Amendment to Permission (ref: 19/04488/FUL) relating to new vehicle entrance, boundary wall and changes to external stairs to lower garden at 5 Cluny Gardens, Edinburgh.

Application No: 20/03062/FUL

DECISION NOTICE

PL/DDM/ICA/CGE/074/LRB
Supporting Statement V1. Final
19th October 2020
John MacCallum BSc. (Hons), MRTPI
Planning Consultant

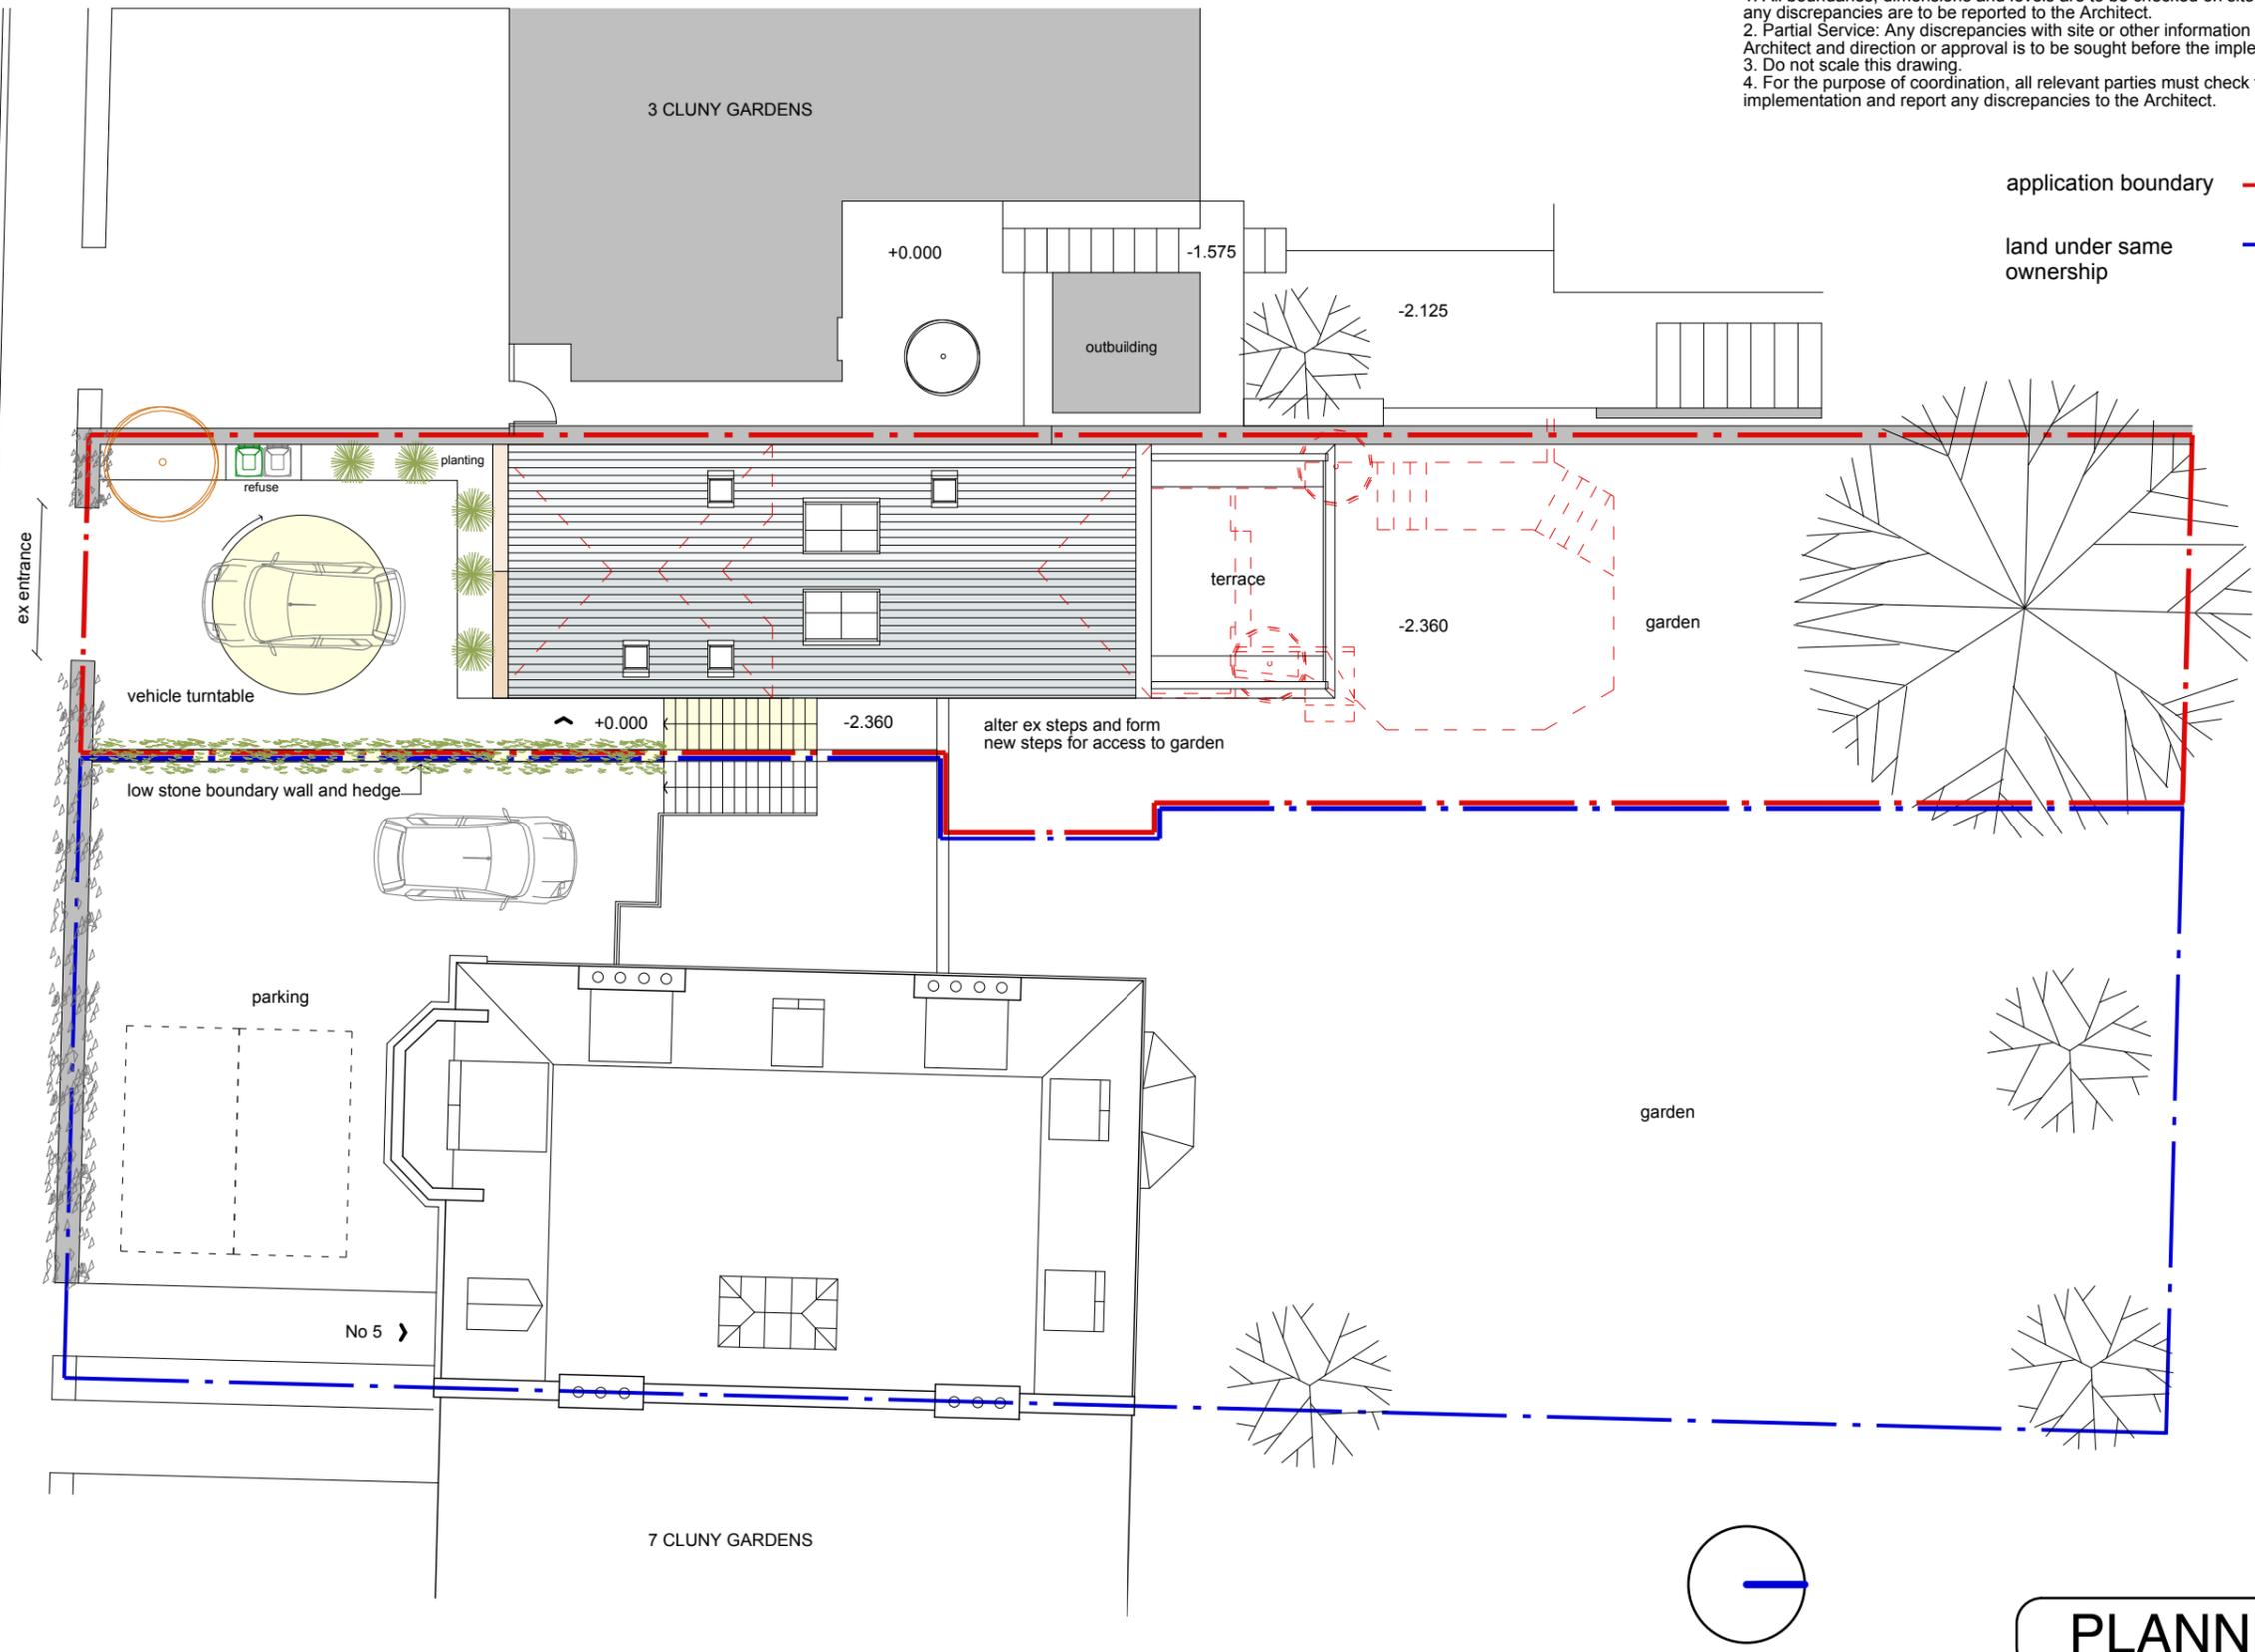
3.1.5 This statement is not correct, as these features form part of application Ref 20/03061/FUL and do **NOT** form part of this application – while they were shown on the Proposed Site Plan, they were for information purposes only as part of this review application to illustrate how the overall situation would appear if details contained in the other separate amendment application (Ref 20/03061/FUL) associated with the permission for the new house (Ref 19/004488/FUL) were implemented.

3.2.1 The amendment sought requires the removal of a short 3 metre wide section of front boundary wall and corresponding hedge along the front of the property in order to form a new vehicular access dedicated for No.5 to access its own car parking area as it presently exists, as shown on the Proposed Site Plan.

EXISTING ELEVATION TO 3-7 CLUNY GARDENS

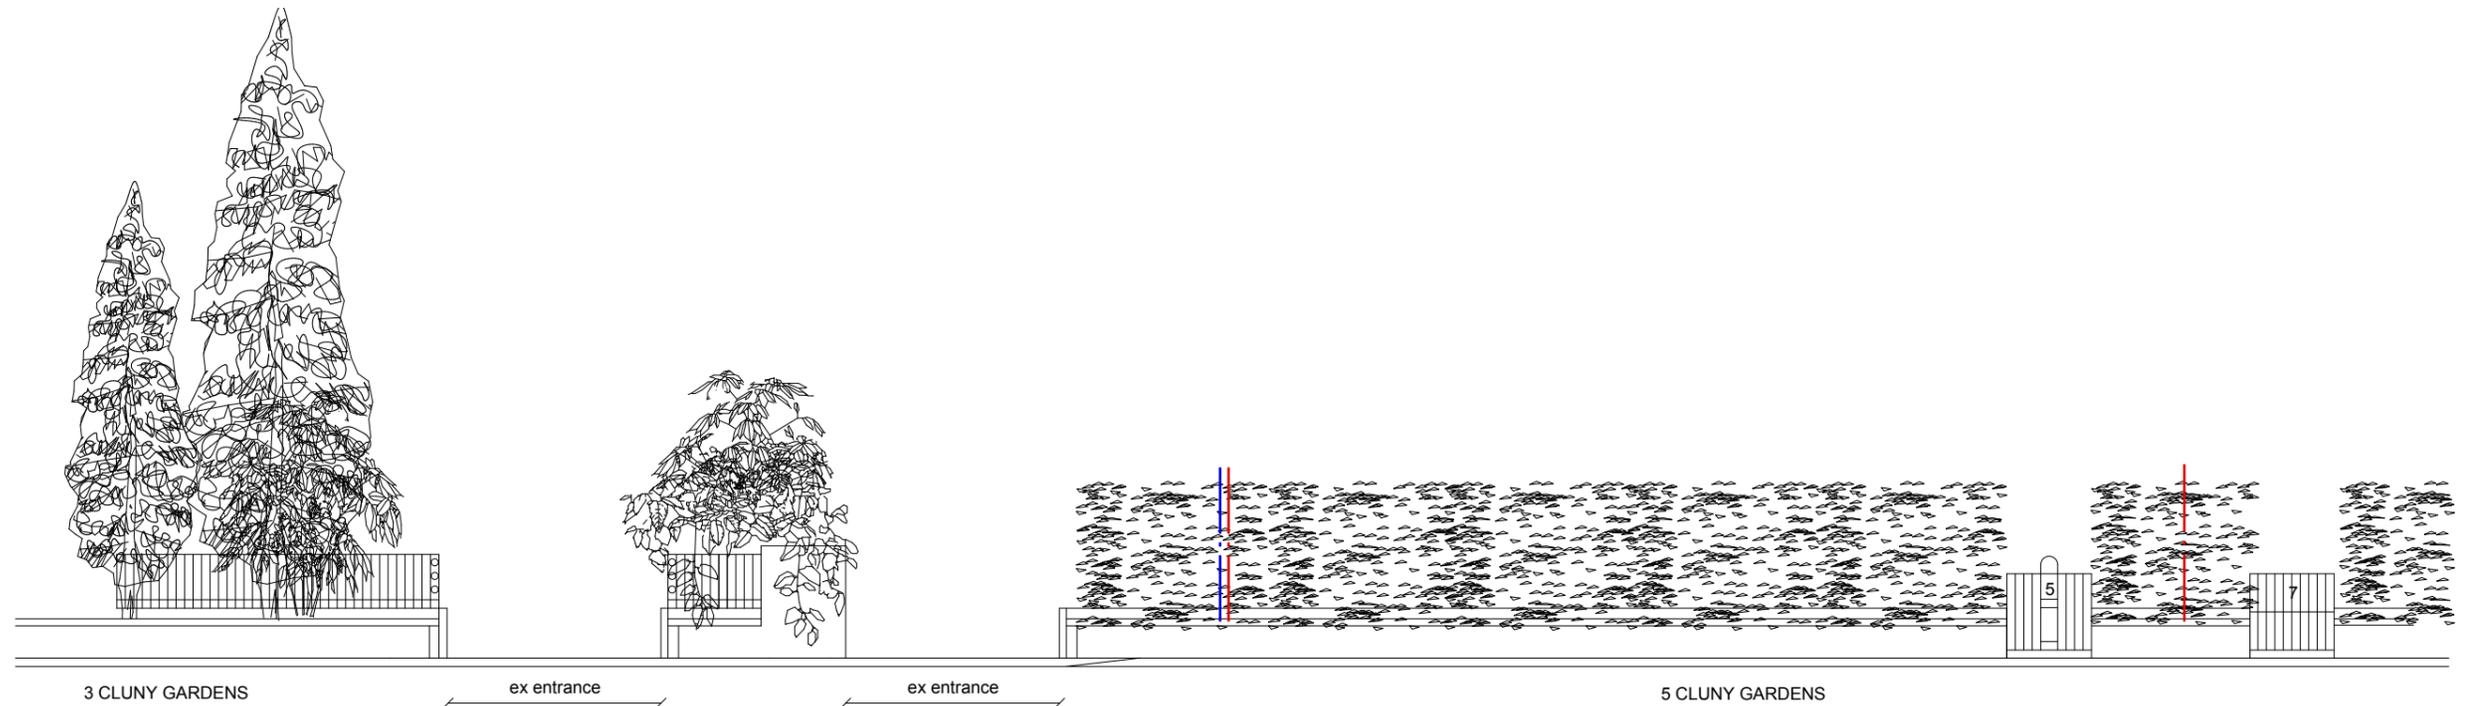
The proposal would remove a 3m wide section of the existing boundary wall adjacent to the existing opening and add a second vehicle access. This is disruptive to the setting of the original villa by virtue of eroding a feature that contributes positively to the character and setting of the property. It is recognised that the design and material of the gate is in keeping with those prevalent in the area. However, its inclusion results in further visible exposure of extensive hardstanding designed primarily for parking within the property's front garden. In this regard, it incrementally erodes the character and setting of the original villa property.

In regard to planning application 20/03062/FUL, the creation of the vehicular access would impact on the conservation area through the loss of the front wall and hedging. There is no planning control over the hedge, however, in tandem with the front boundary wall these are features that contribute positively to the character of the conservation area. Removal of this section of the front boundary wall would not preserve or enhance the conservation area contrary to the LDP policy Env 6. The design of the replacement gate is noted, however the proposal is still unacceptable in terms of the loss of these features.
